## CITY OF TONTITOWN PLANNING OFFICE

Meeting: **February 23, 2021**  
Project: **Grease Monkey**  
Planner: Courtney McNair, Garver

### PRELIMINARY LARGE-SCALE DEVELOPMENT PLAN APPROVAL REQUEST

**SUMMARY:** Grease Monkey is requesting Preliminary Large-Scale Development (LSD) approval for a 4,430 SF commercial building on 1.15 acres.

**SHEET NUMBER**  
C1.01

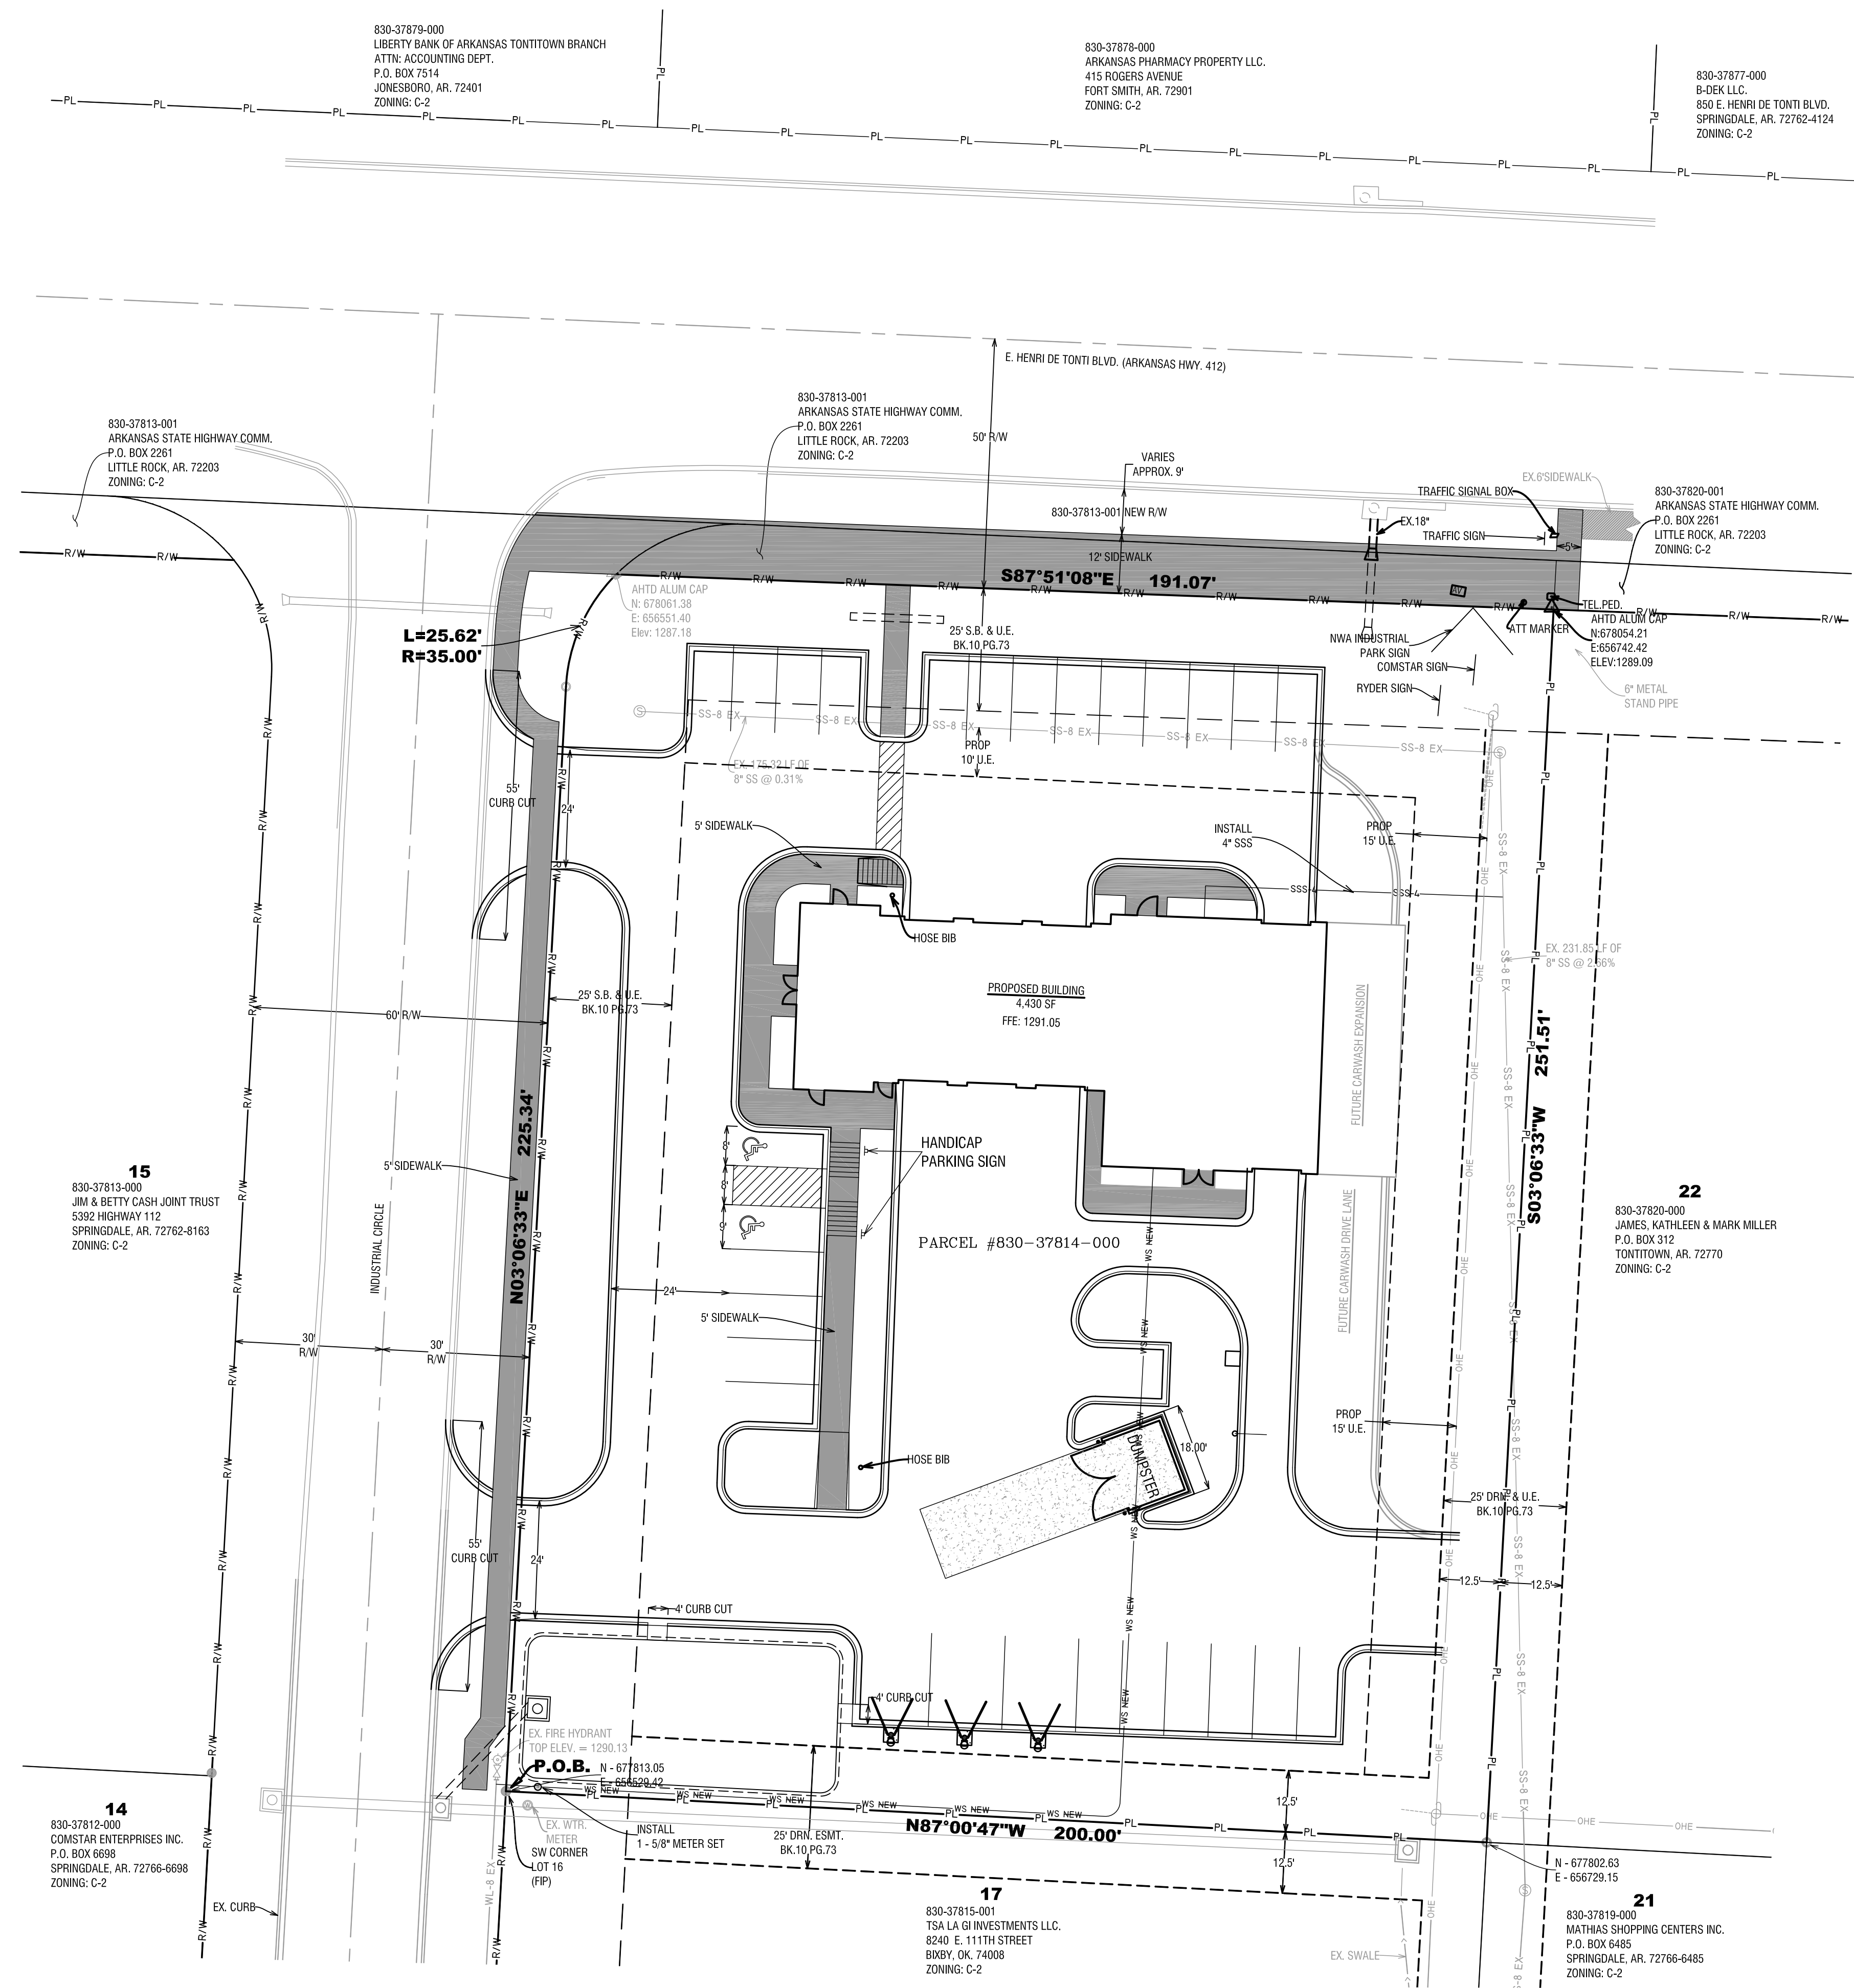
There is one (1) existing hydrant shown at the southwest corner of this site. No additional hydrants are proposed. No fire flow data was provided. The gpm (gallons per minute) flow data is required to be shown on this plan.

The required cross-access drive is located on the southern portion of this property due to multiple conflicts on the north side. This access drive will need to have an access easement added for future connectivity.

Revised Building Elevations and Plans were submitted to show compliance with the required design standards. The square footage of each use will need to be shown on the site plans.

3. The SWPPP must be completed and posted on site prior to construction.
4. The gpm (gallons per minute) flow data for the existing fire hydrant shall be shown on this plan.

10. The required cross-access drive shall be required to be an access easement added for future connectivity. This easement shall be shown on the plans.

11. The square footage of each use within the building shall be shown on the site plans.
12. Correct the Landscape Plan to clarify the following:
  - "Sugar Maple" is shown in the Plant List table, but the applicant has stated this tree will not be used in this location. It appears to be a typo and should be replaced with the intended "Golden Raintree".

SHEET NUMBER  
L1.00

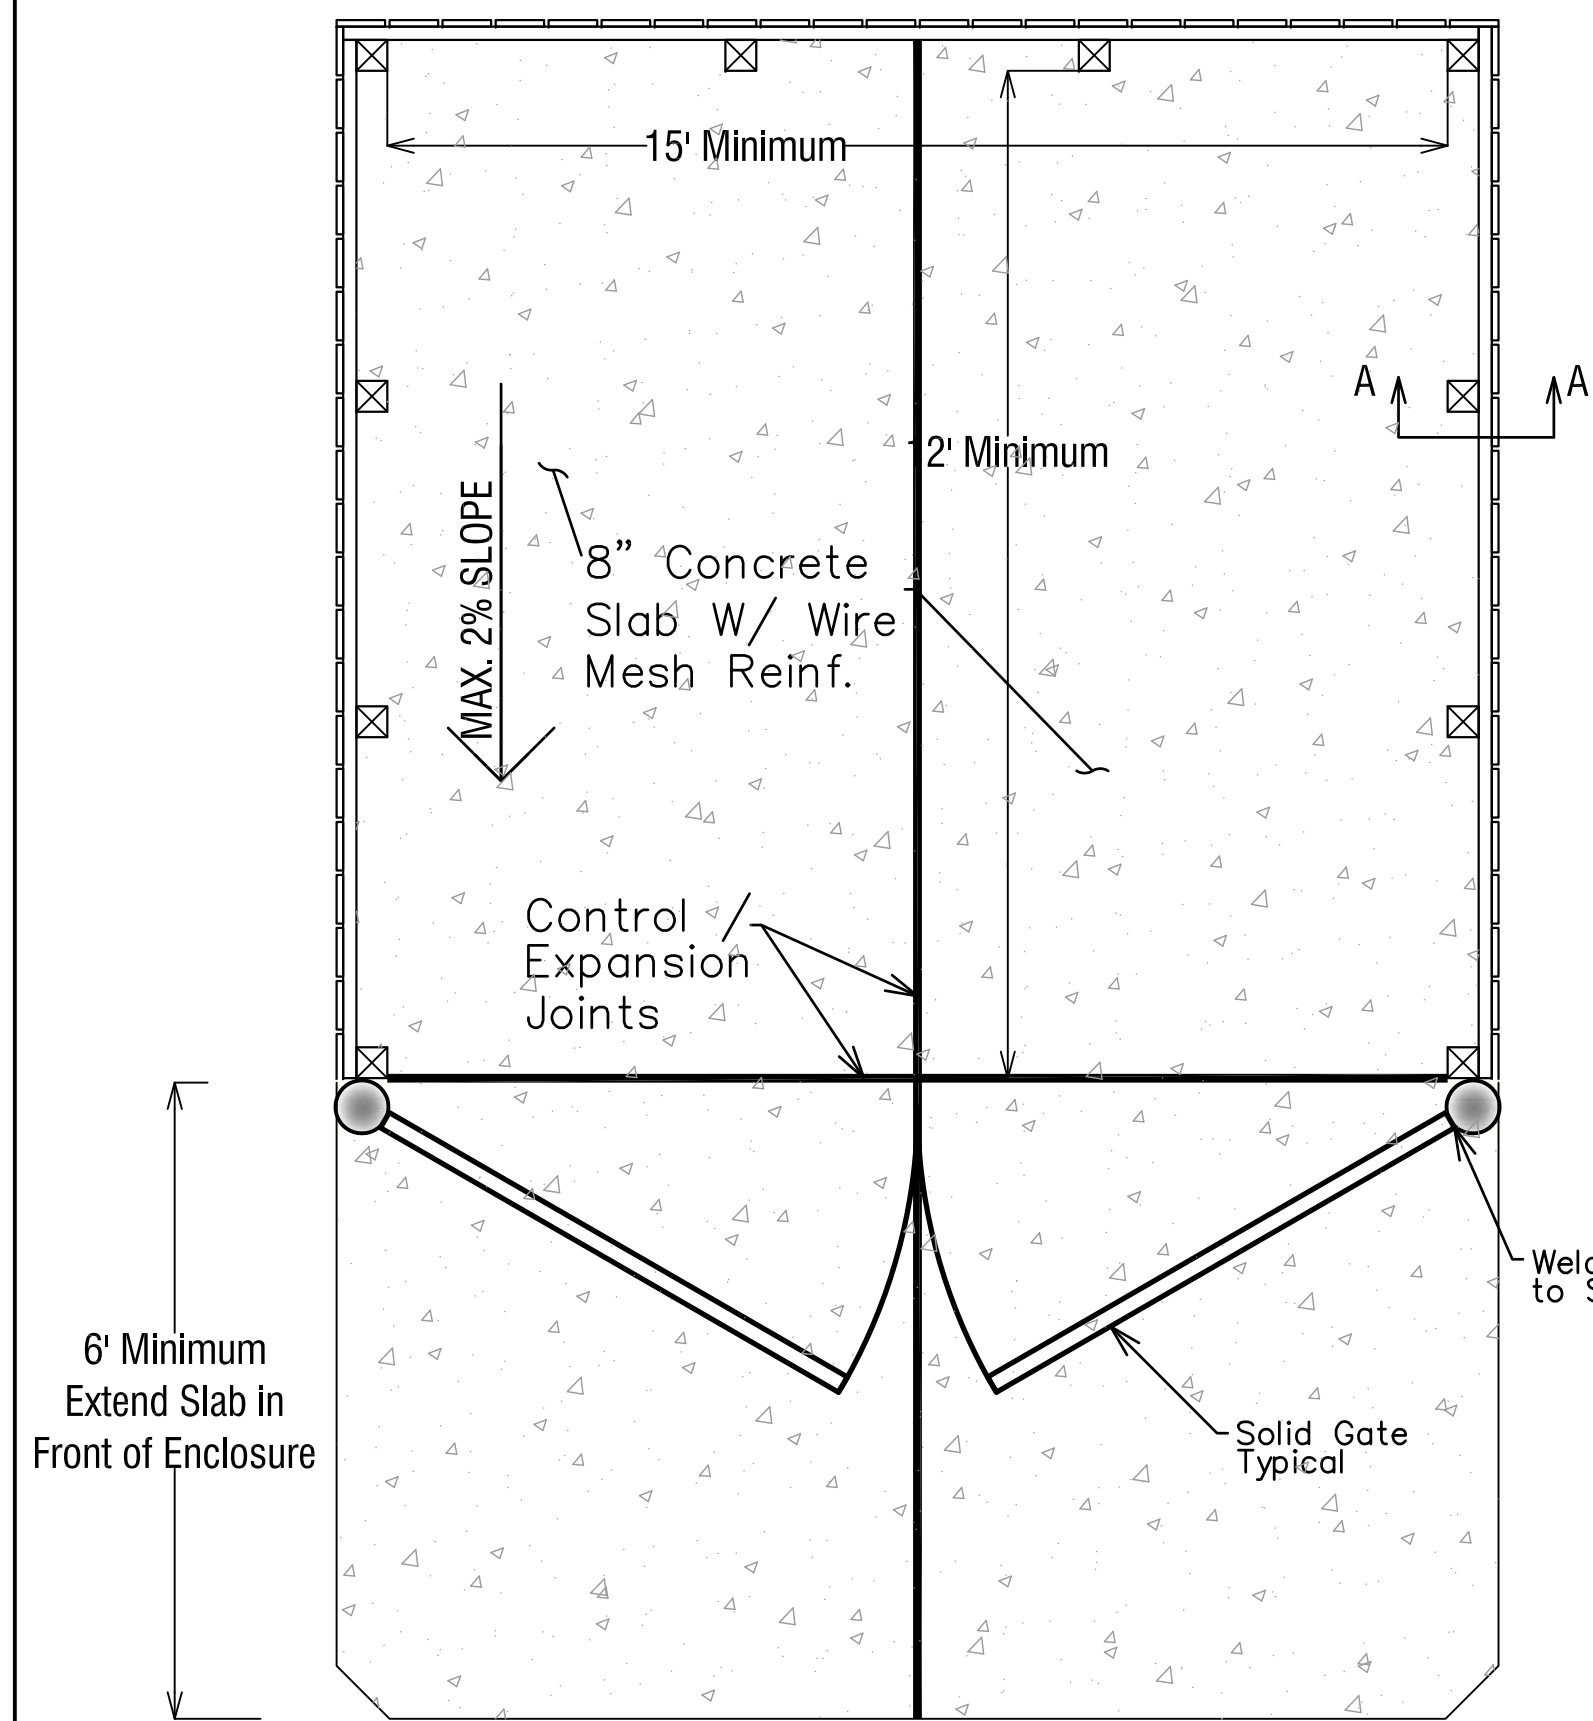
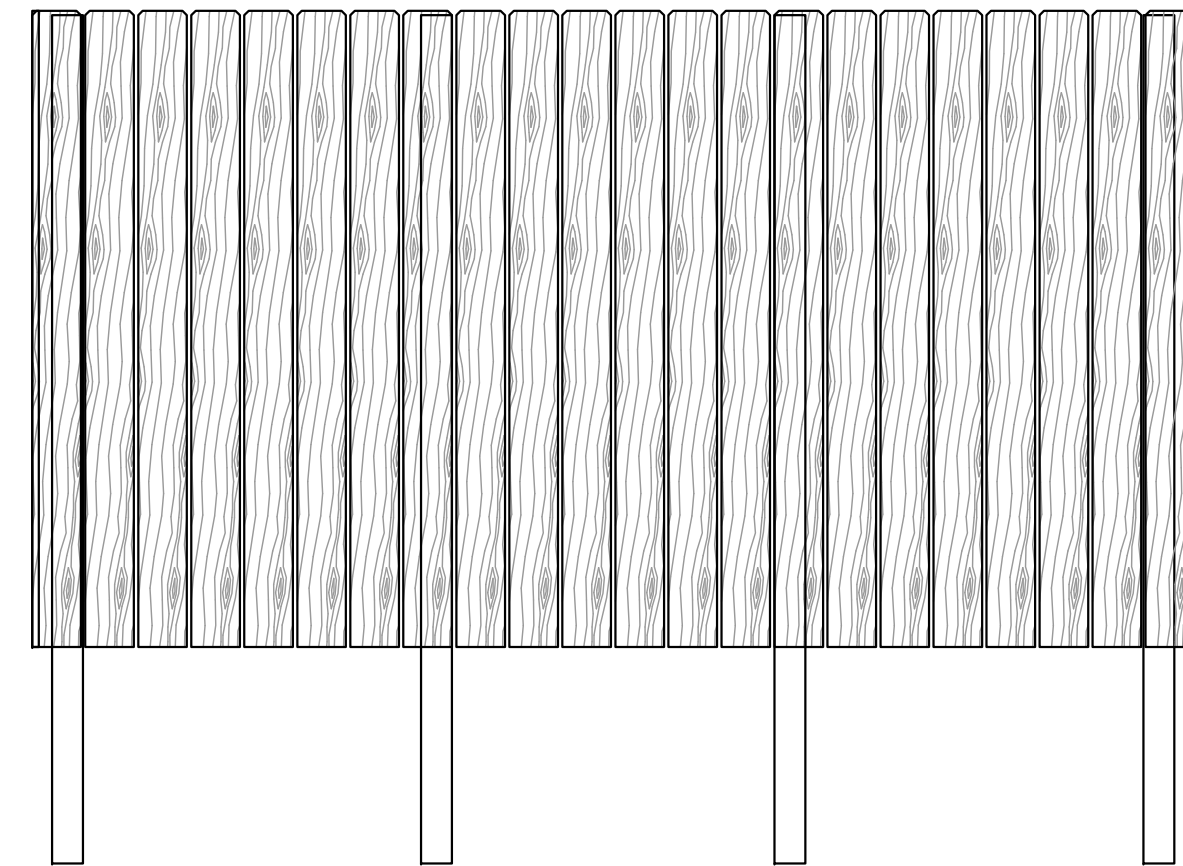
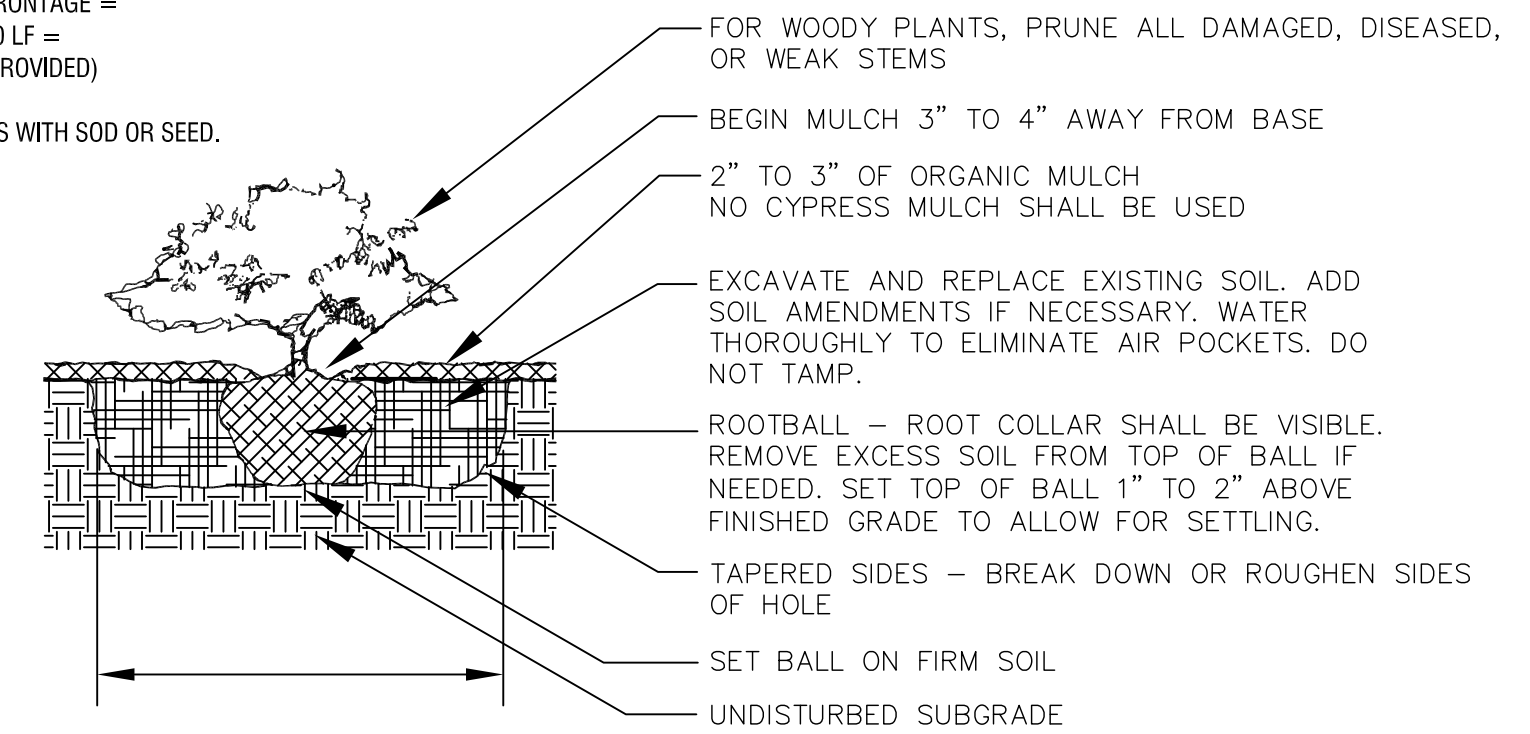
- The Landscape Plans is showing "Sugar Maple" in the Plant List table, but the applicant has stated this tree will not be used in this location. It appears to be a typo, and should be replaced with the intended "Golden Raintree".
- There is a note on the plans that states "Required landscaping shall be irrigated by an underground sprinkler system" which is in contrast to the stated information in the resubmitted checklist and the hose bibs shown on the plan. If both are to be used, please provide clarification.

- There is a note on the plans that states "Required landscaping shall be irrigated by an underground sprinkler system" which is in contrast to the stated information in the resubmitted checklist and the hose bibs shown on the plan. If both are to be used, please provide clarification.
